MACARTHUR TRANSIT VILLAGE

SEPTEMBER 28, 2016

ORIGINAL FDP (& DRC) GROUND FLOOR PLAN

PROPOSED GROUND FLOOR PLAN

ORIGINAL FDP (& DRC)

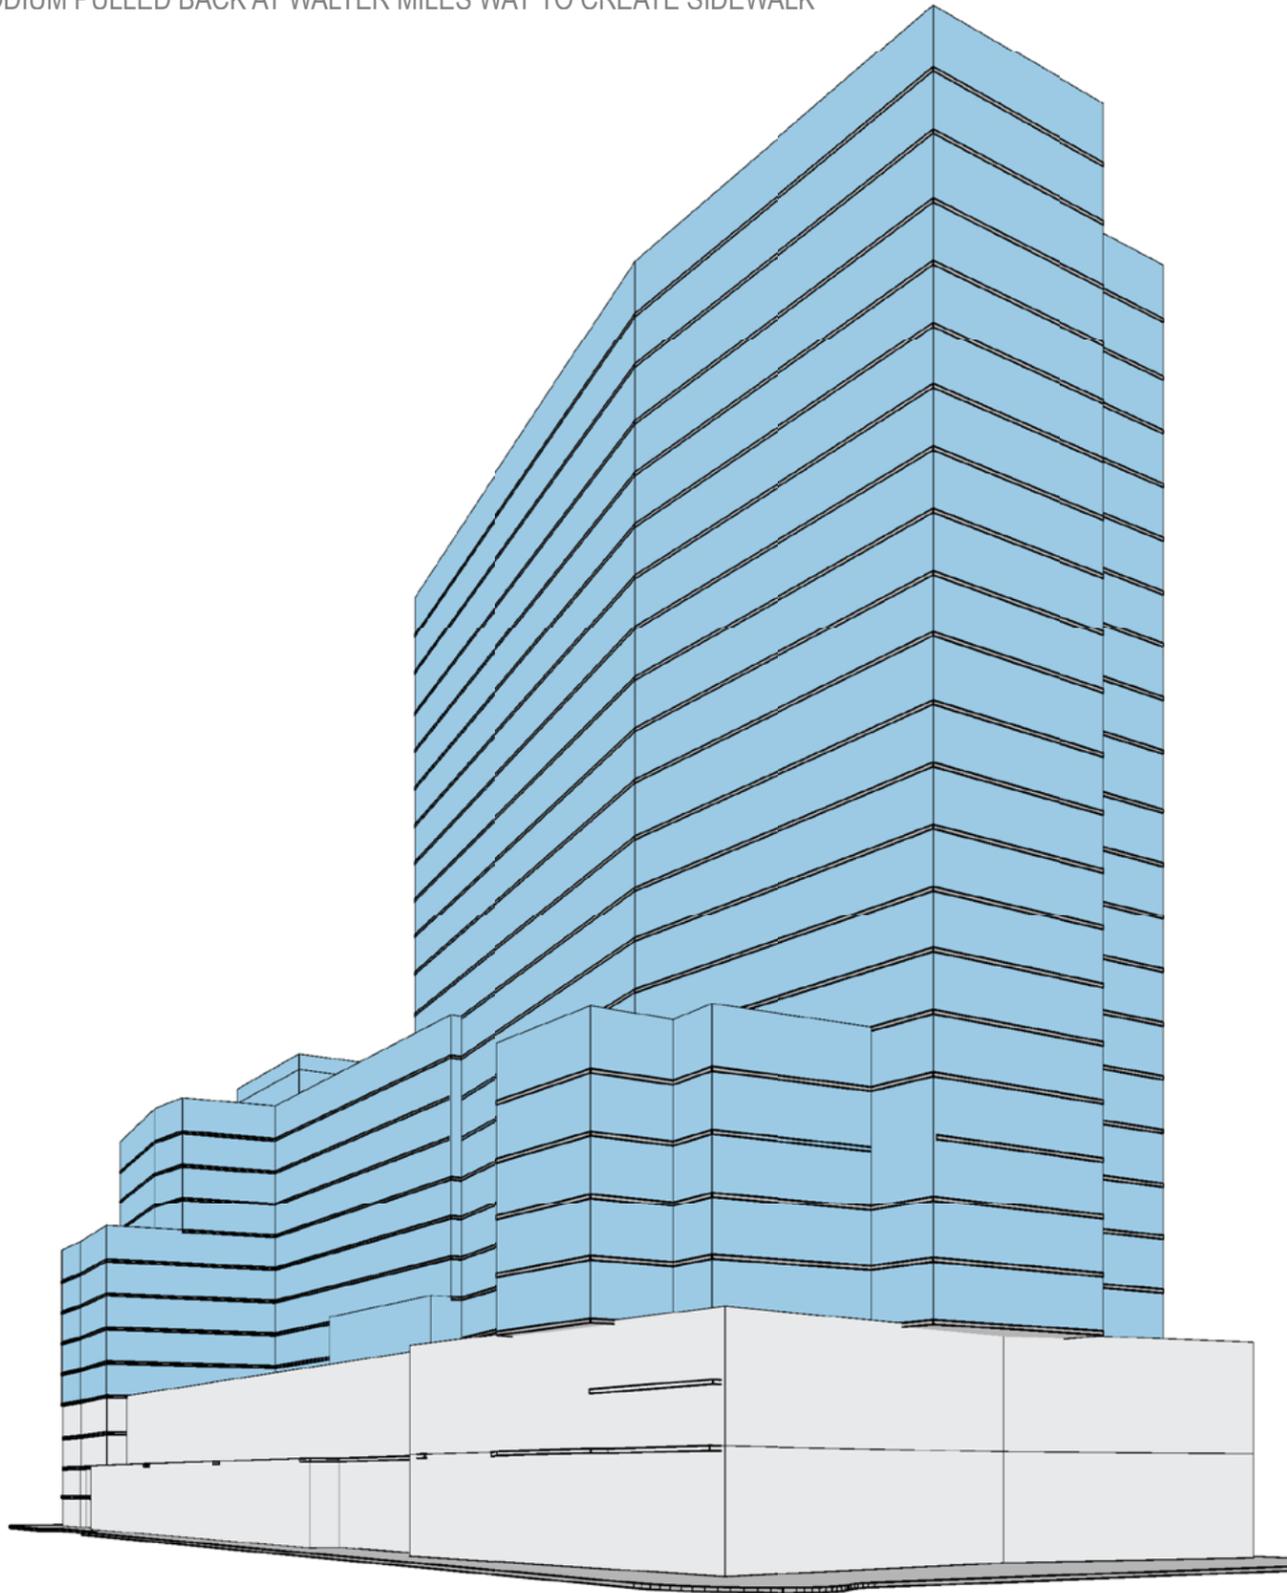
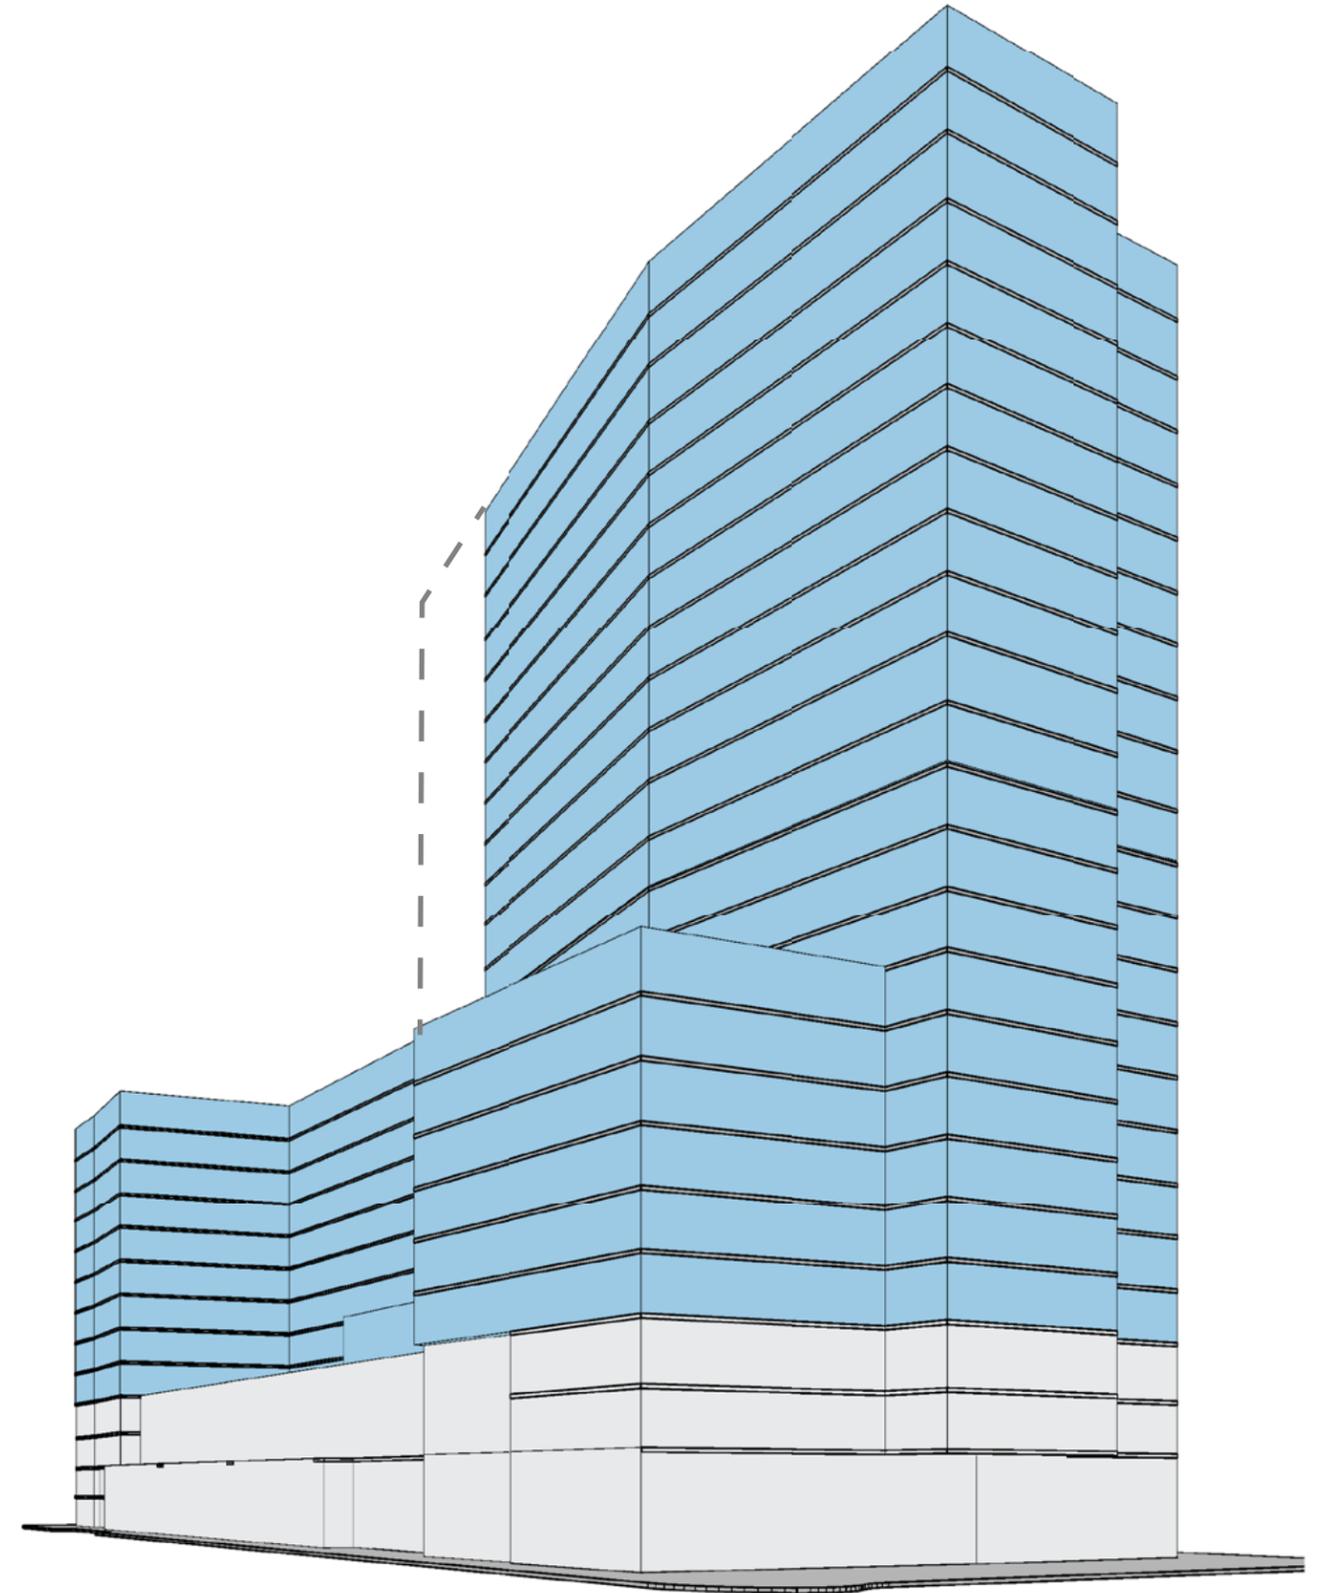
TOWER LENGTH REDUCED BY 40' FROM 192' TO 152'
TOWER FLOORPLATE REDUCED FROM 12,500SF TO APPROX 10,000SF
SOME AREA REDUCTION BY STANDARDISING UNIT MIX.
RESIDUAL TOWER VOLUME REDISTRIBUTED TO PODIUM WINGS
PODIUM PULLED BACK AT WALTER MILES WAY TO CREATE SIDEWALK
